# Skew in 400GbE

**IEEE P802.3bs 400 Gb/s Ethernet Task Force**

Table 116-4—Summary of Skew constraints

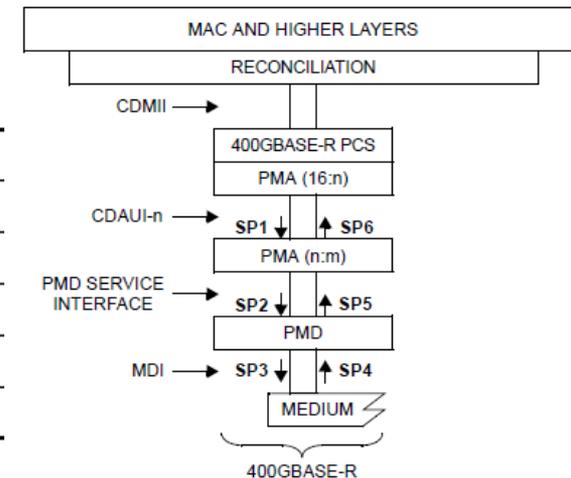
- Draft 1.2 currently have all skew numbers in magenta
- The values are all copied directly from 100GbE
- This looks at 400GbE and should we leave the numbers as is or change them?

➤ Numbers straight from 100GbE

Table 116–5—Summary of Skew Variation constraints

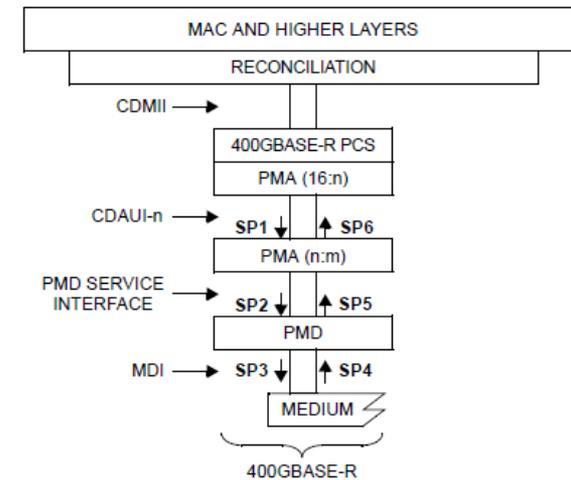
➤ Numbers straight from 100GbE
